Date of Issue: July 2015

Affected Publication: API Recommended Practice 17V, *Recommended Practice for Analysis, Design, Installation, and Testing of Safety Systems for Subsea Applications*, First Edition, February 2015

ERRATA

Figure 1—API RP 17V Scope

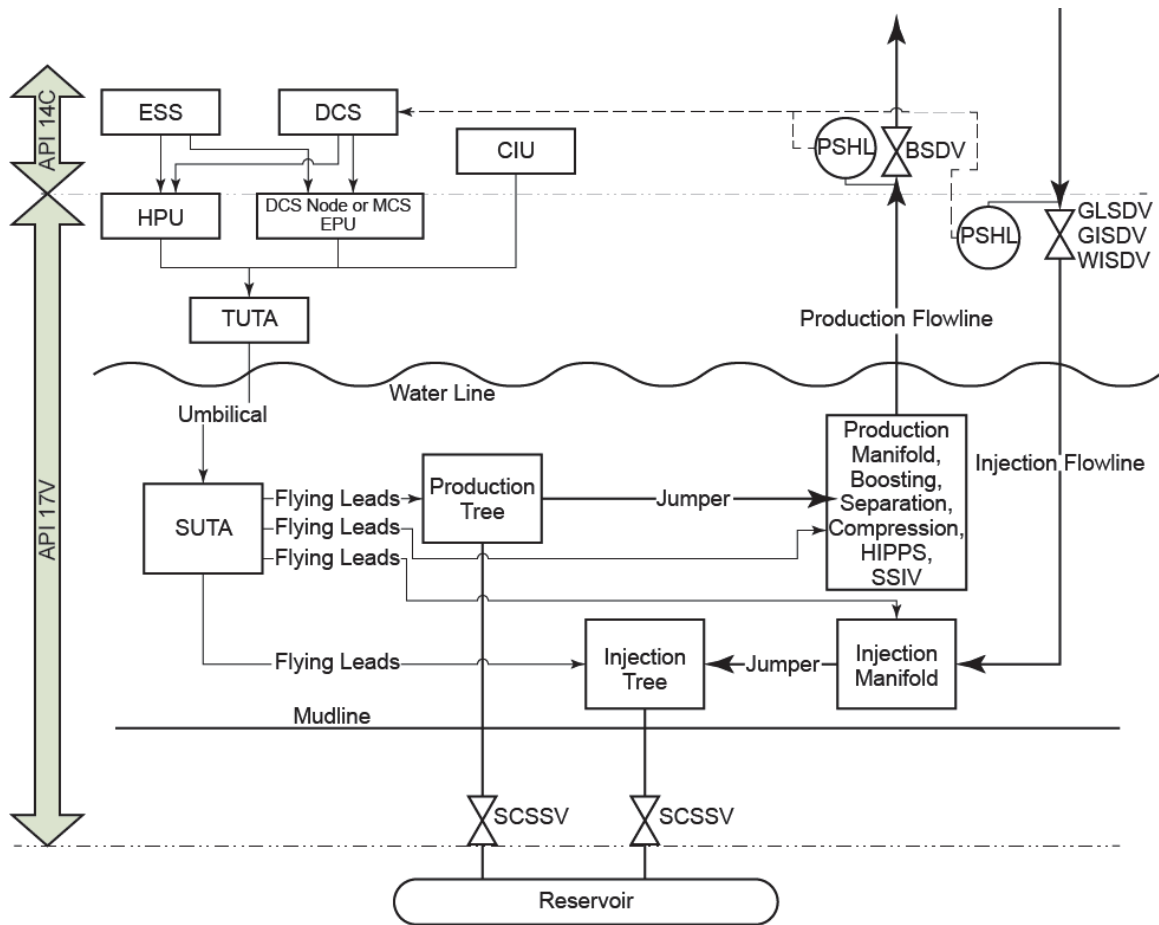
Page 1, replace Figure 1 with the following:
